City of Carlisle, Iowa  
Planning and Zoning Commission  
Regular Meeting  
March 15, 2021  
7:00 P.M.  
Carlisle City Hall

RE: **Danamere Farms Plat 10 – Construction Plan Review**  
**Carlisle, Iowa**  
*FOX Ref No: 8666-03C.259*

FOX Engineering has completed the second review for of the Danamere Farms Plat 10 (formerly Danamere Plat 9) Construction Plans, dated March 10, 2021 and offer the following comments:

# DANAMERE PLAT 10 CONSTRUCTION DRAWINGS

**STORM SEWER  
 PLAN & PROFILE**

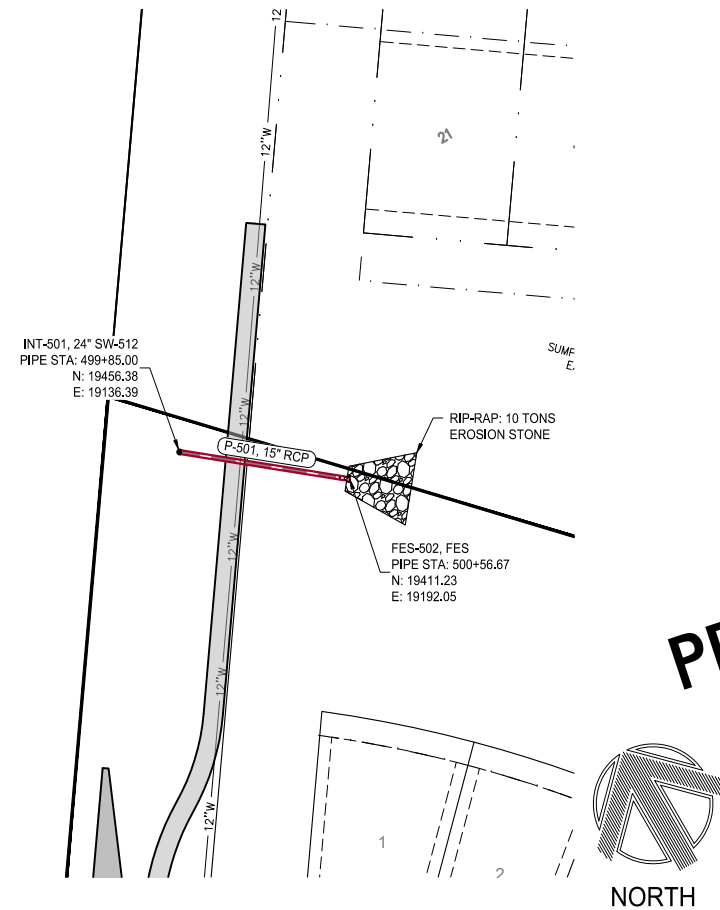
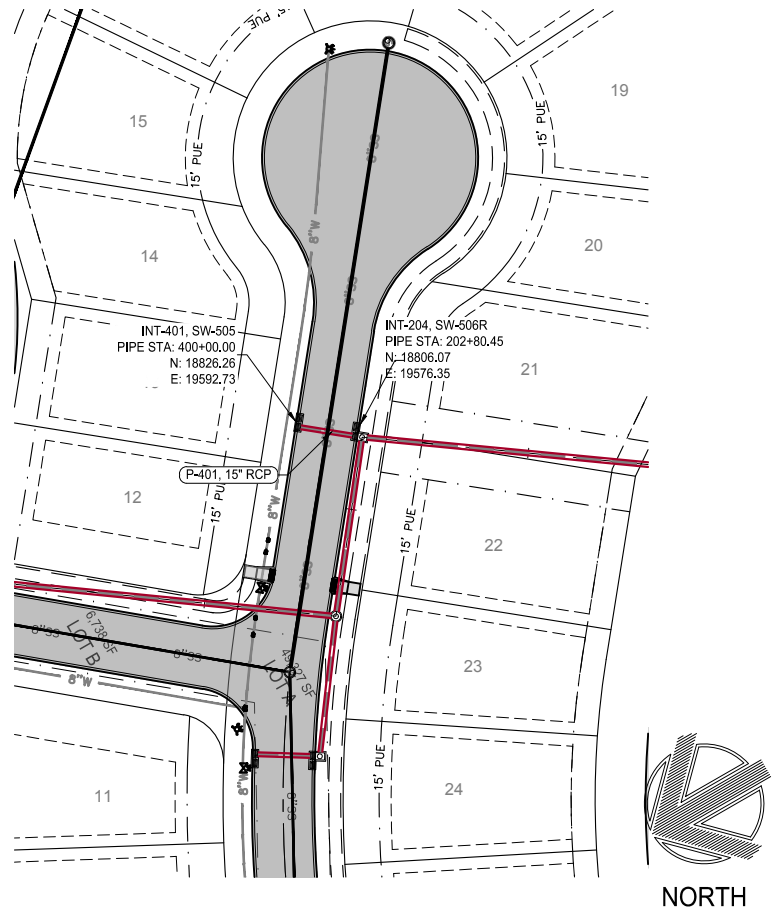
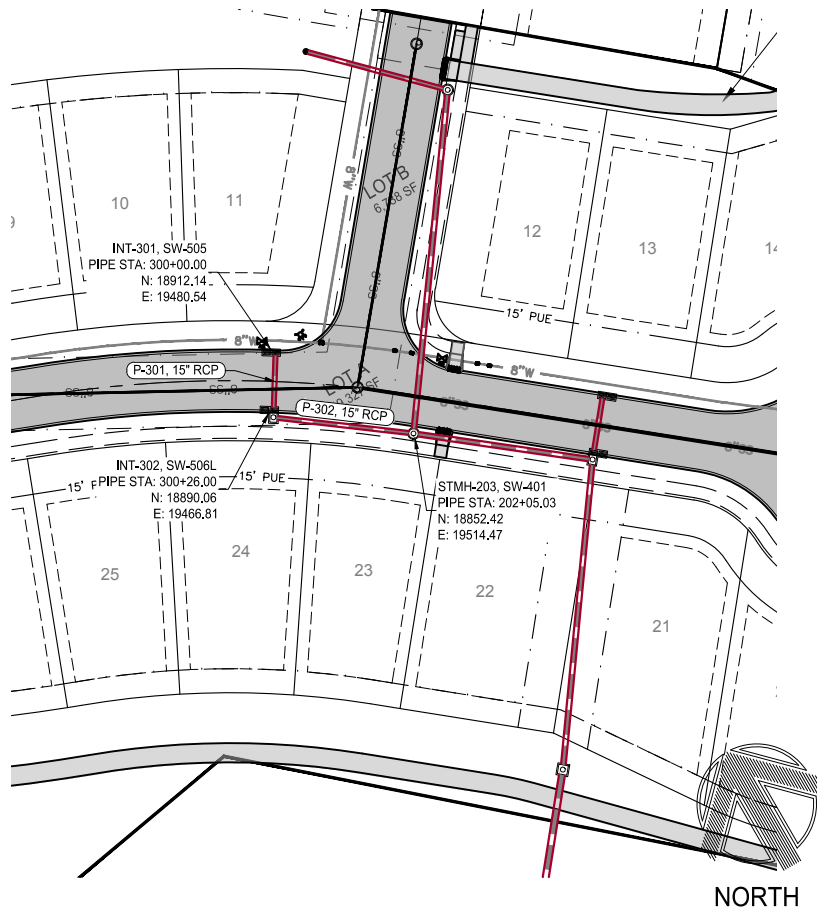
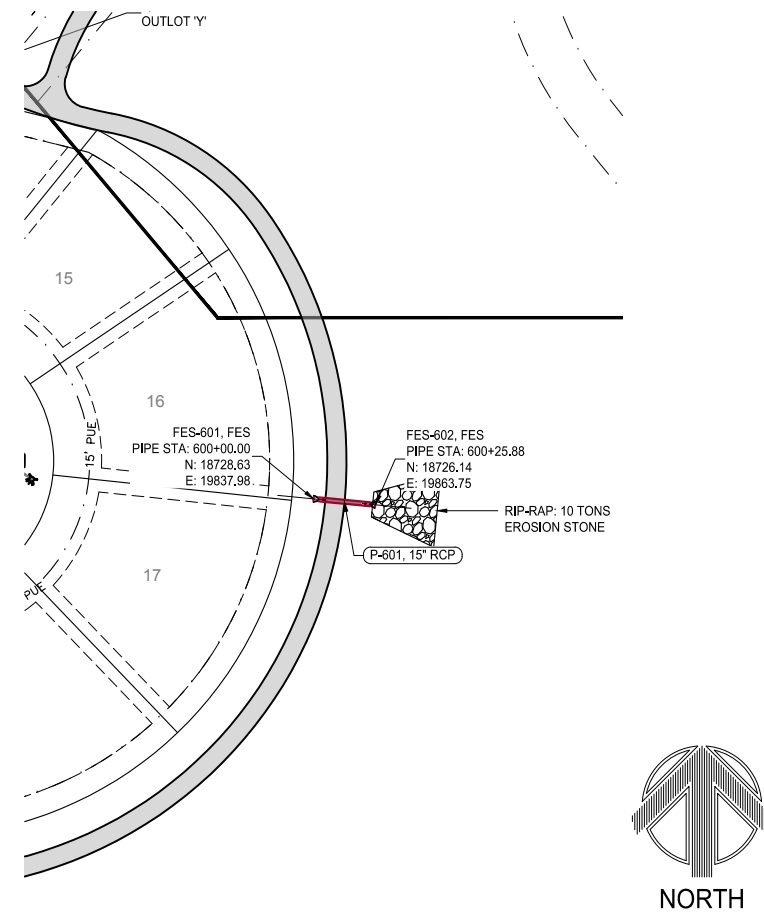
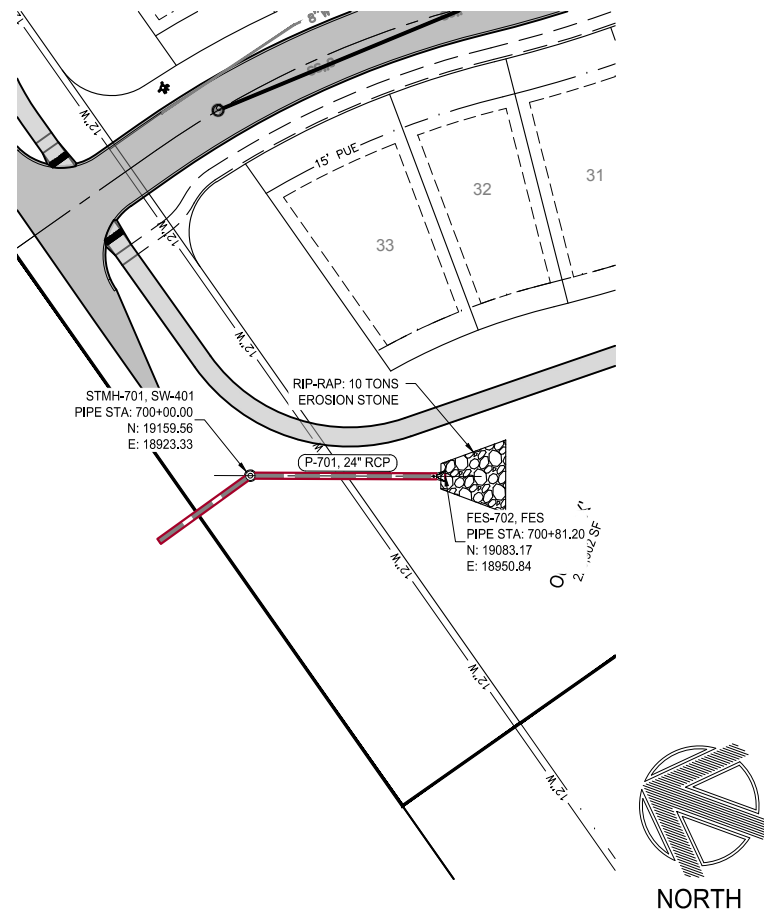
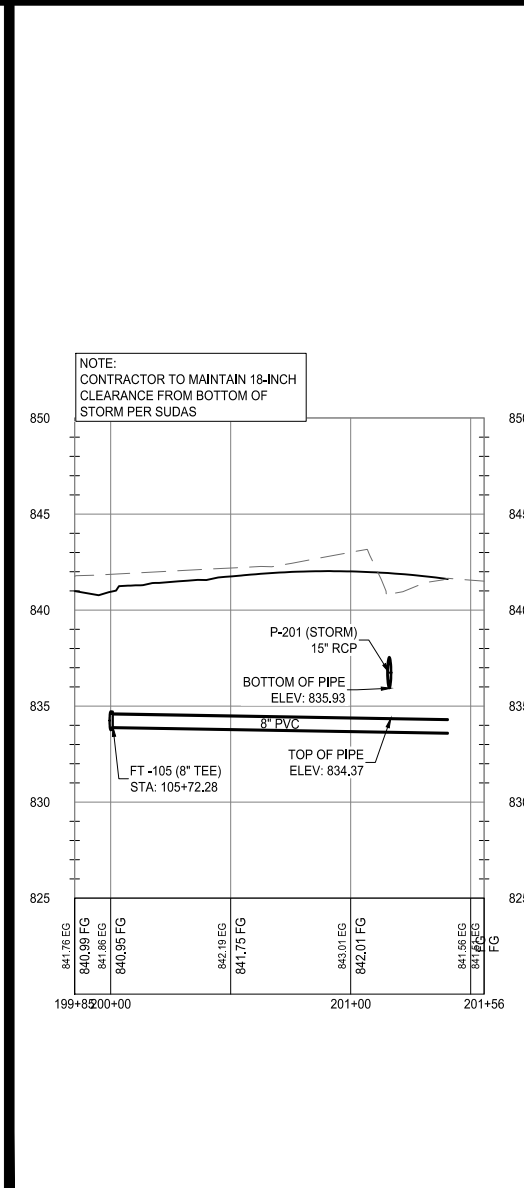
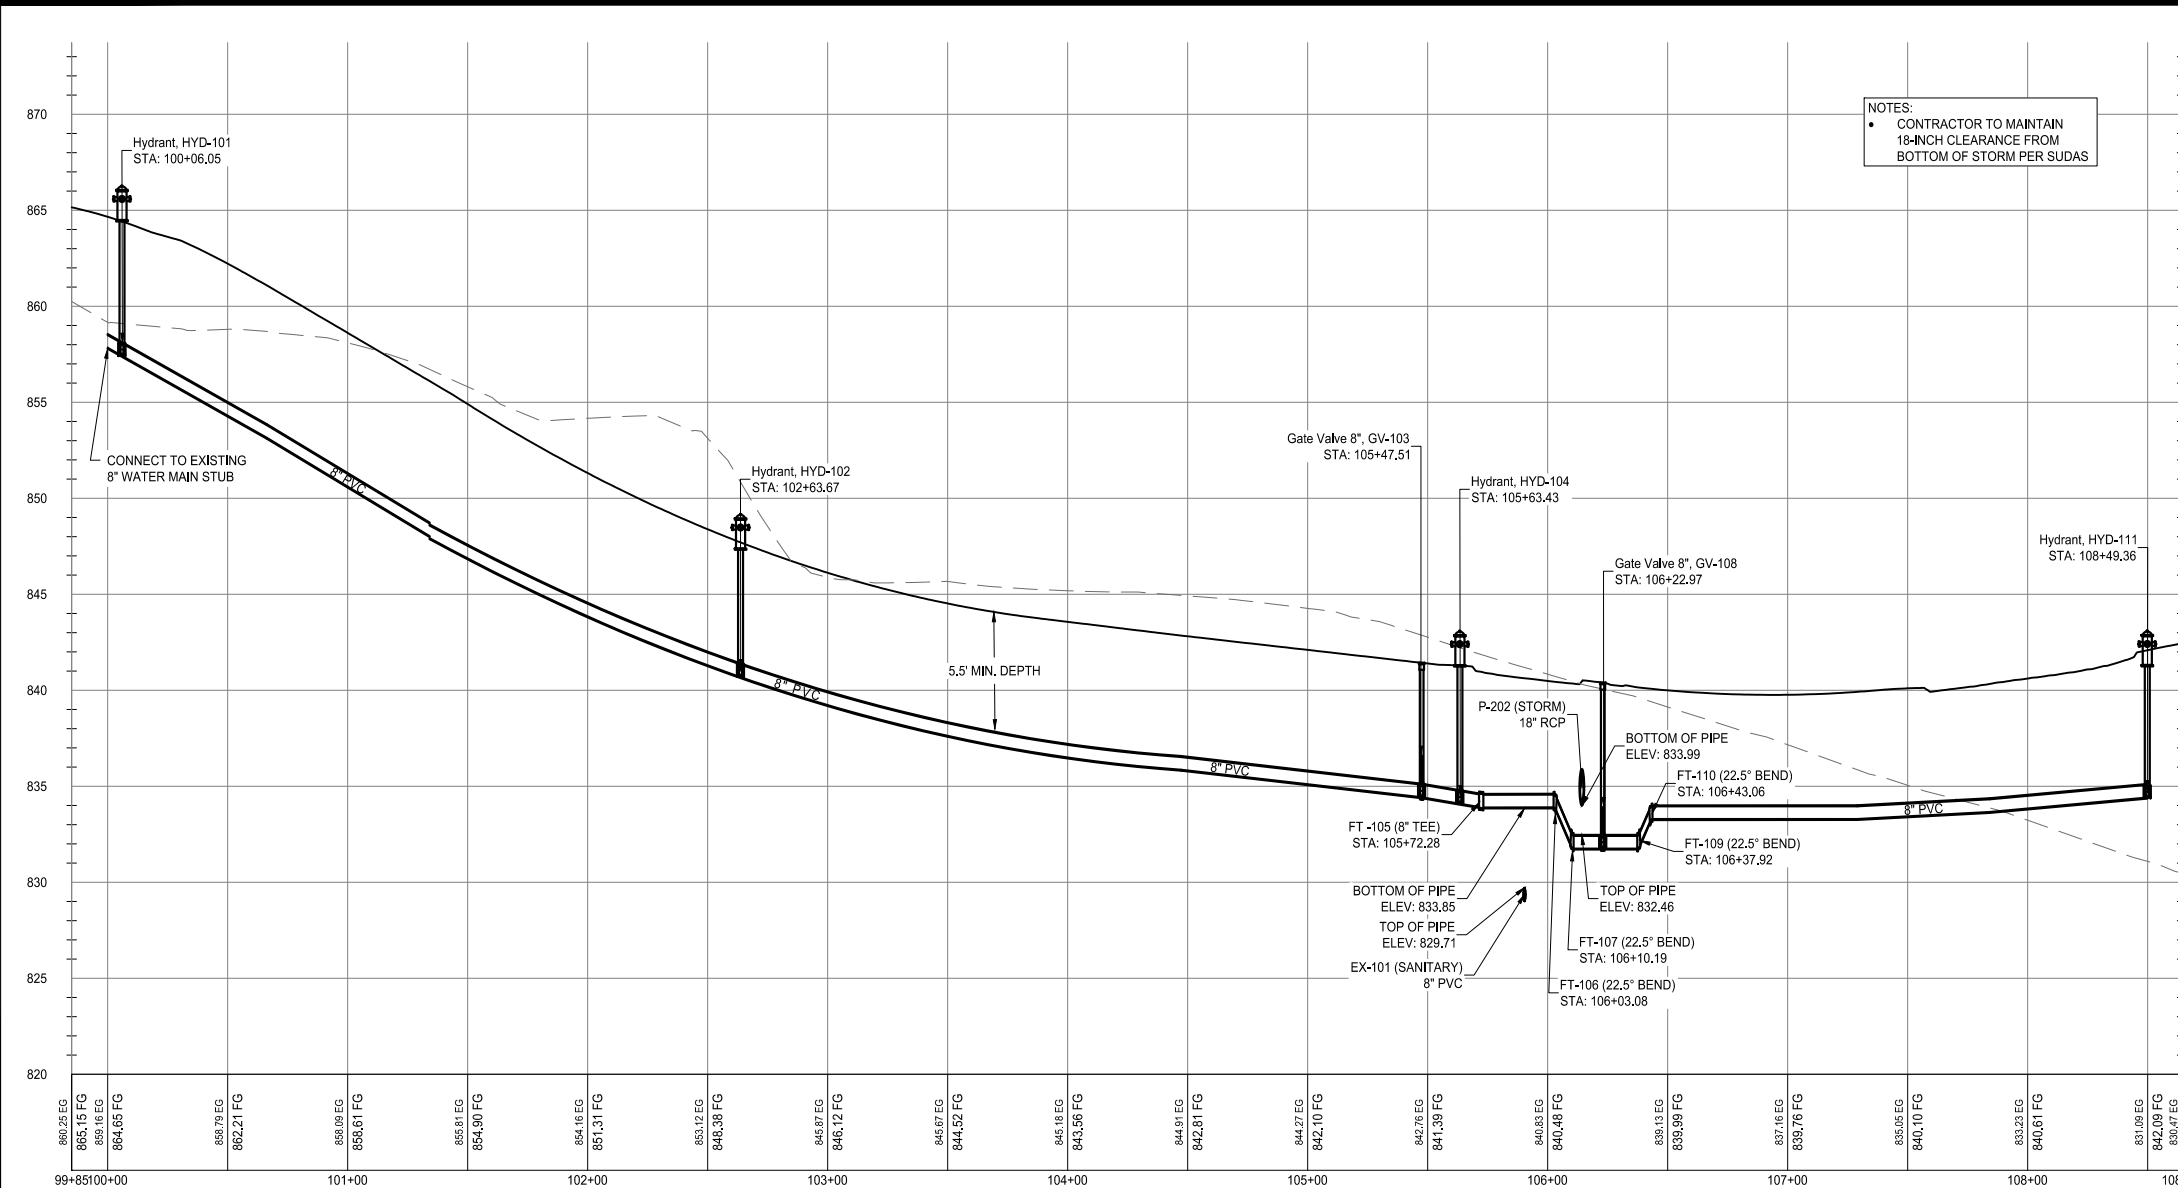
### **Sheet 7, 8 & 9 – Storm Sewer Plan and Profile**

14. Please dimension the rip rap placement (length and width)
